# Recall Bulletin

## PRODUCT SAFETY RECALL

**SUBJECT:** Brake Pedal Pivot Nut/Bolt Loose

**MODELS:** 2015 - 2016 Chevrolet Silverado LD, HD  
2015 - 2016 Chevrolet Tahoe PPV (RPO 9C1)  
2015 - 2016 Chevrolet Tahoe Special Services (RPO 5W4)  
2015 - 2016 GMC Sierra HD

4404307

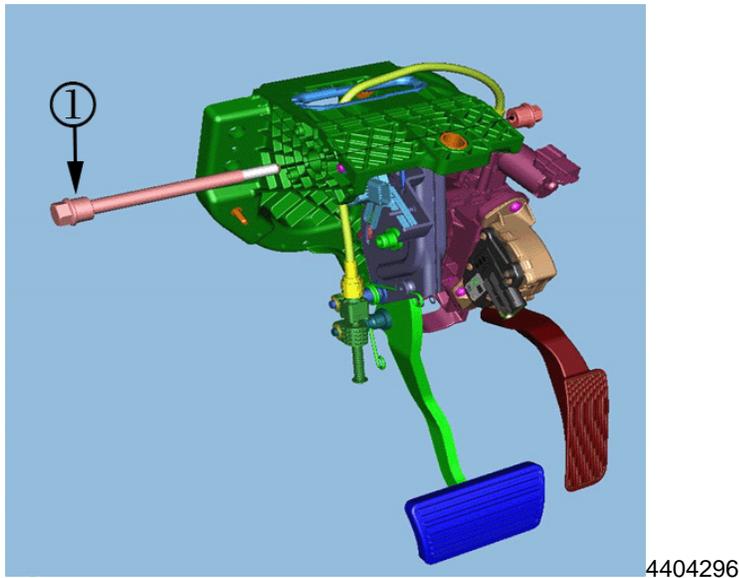
- Using an inspection mirror, determine if the brake pedal pivot nut is on the outboard side of the vehicle.

- If the brake pedal pivot nut (1) is on the outboard side of the vehicle, proceed to step 2.

- If the brake pedal pivot bolt (1) is on the outboard side of the vehicle (nut on the inboard side), no further action is required.
2. Determine if the vehicle is equipped with a manual or automatic transmission.
    - If the vehicle is equipped with a manual transmission remove the clutch pedal. Refer to *Clutch Pedal Replacement* in SI. After the clutch pedal has been removed, proceed to step 5.
    - If the vehicle is equipped with an automatic transmission, proceed to step 3.
  3. Remove the Instrument Panel Knee Bolster. Refer to *Instrument Panel Knee Bolster Replacement* in SI.
  4. Remove the Floor Front Air Outlet Duct - Left Side. Refer to *Floor Front Air Outlet Duct Replacement - Left Side* in SI.

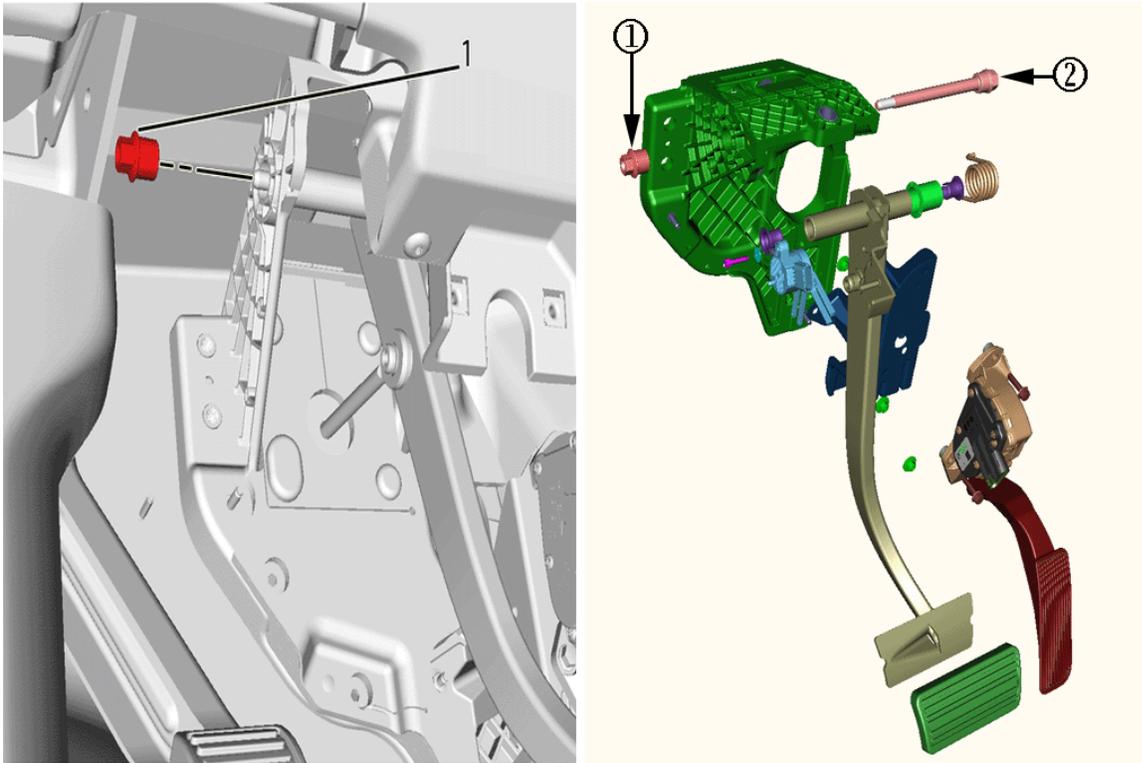
**Caution:** Apply pressure to the brake pedal pivot bolt while removing the nut to ensure the bolt does not back out of the housing. Part damage could occur if the bolt backs out of the housing.

5. Holding the brake pedal pivot bolt (2) with a box end wrench, remove the brake pedal pivot nut (1).

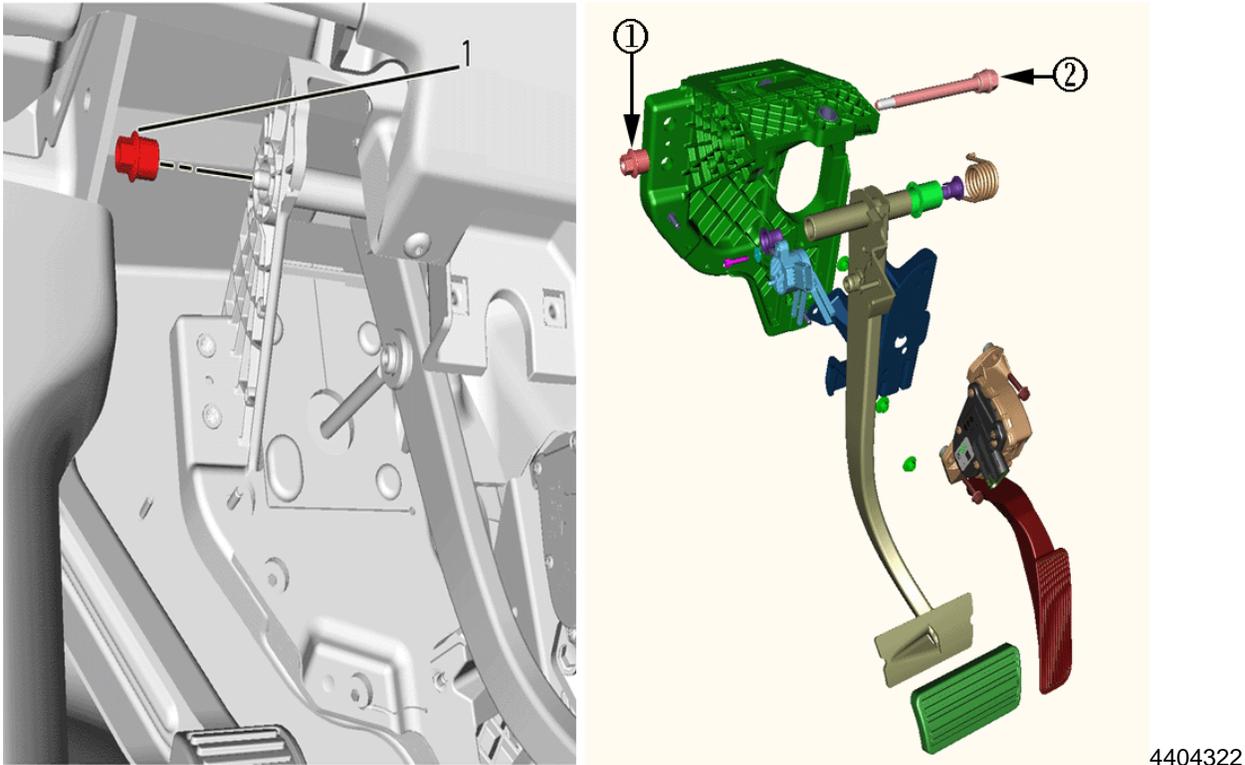
**Note:** Do NOT get threadlocker on the exterior of the brake pedal pivot nut. The exterior of the brake pedal pivot nut must be kept clean of threadlocker.

6. Holding the nut horizontally, apply two drops of red threadlocker to the threads in the collar portion (1) of the nut.

7. Holding the brake pedal pivot bolt (2) with a box end wrench, install the brake pedal pivot nut (1).
8. Holding the brake pedal pivot bolt with a box end wrench, torque the brake pedal pivot nut to 26 Nm (19 lb ft).
9. On vehicles equipped with a manual transmission, install the clutch pedal. Refer to *Clutch Pedal Replacement* in SI.
10. Install the Floor Front Air Outlet Duct - Left Side. Refer to *Floor Front Air Outlet Duct Replacement - Left Side* in SI.
11. Install the Instrument Panel Knee Bolster. Refer to *Instrument Panel Knee Bolster Replacement* in SI.
